## CITY OF HIGH POINT AGENDA ITEM

Title:	<b>SP-15-0</b> WI High	<b>)10</b> Point Landfill, LLC		
From:	Lee Burr Director	nette, Planning & Development	Meeting Date:	November 02, 2015
Public Hearing: No		Advertising Date: Advertised By:	NA NA	
Attachn	nents:	<ul><li>A. Staff Report</li><li>B. Applicant's Findings</li></ul>

#### STAFF REPORT (Case # SP-15-0010) MAJOR WATERSHED VARIANCE November 2, 2015

## RE: TRC Watershed Plan Application & Major Variance Request High Point C&D Landfill Jamestown, North Carolina

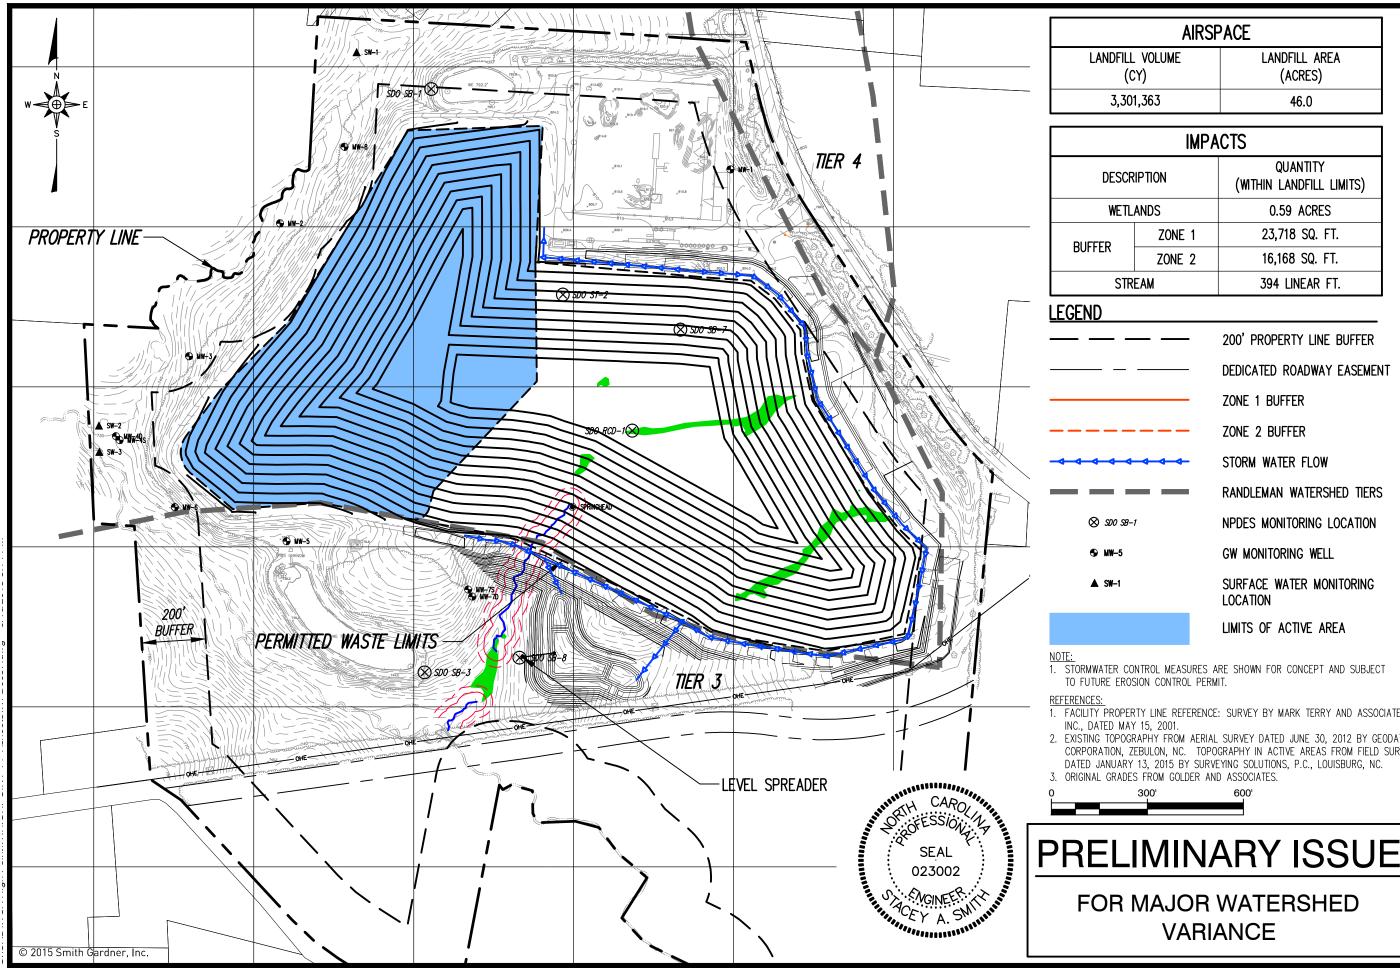
The City's Watershed Review Committee (WRC) met with the applicant in late August, 2015 to discuss the permitting history and proposed findings outlined above. The formal proposal was reviewed in late September, 2015. The WRC supports the arguments and evidence presented by the applicant to allow the disturbance of the stream buffers for a length of 394

linear feet resulting in buffer disturbance areas as outlined in Table 2 (attached documentation).

Staff's findings are based on the belief that the applicant's proposal is the best option to allow design capacity of the C&D landfill while adequately treating storm water runoff from the landfill prior to re-introducing the surface water flow back into the undisturbed stream channel south of the landfill.

Staff recommends approval subject to the following conditions:

- 1. A Site Plan (including the Watershed Control Plan component) is approved by the Technical Review Committee (TRC) prior to disturbance within the buffer area.
- 2. Issuance of the applicable 404/401 permits.
- 3. High Point reserves the right to approve the compensatory mitigation method. Details of the compensatory mitigation requirements would be evaluated and determined during the CWA 404/401 permitting process. Mitigation will be one or a combination of the following: in-lieu fee payment (local stream restoration project), mitigation bank payment (tagged for local projects), on-site preservation of streams and buffers, and increased stormwater control and treatment.
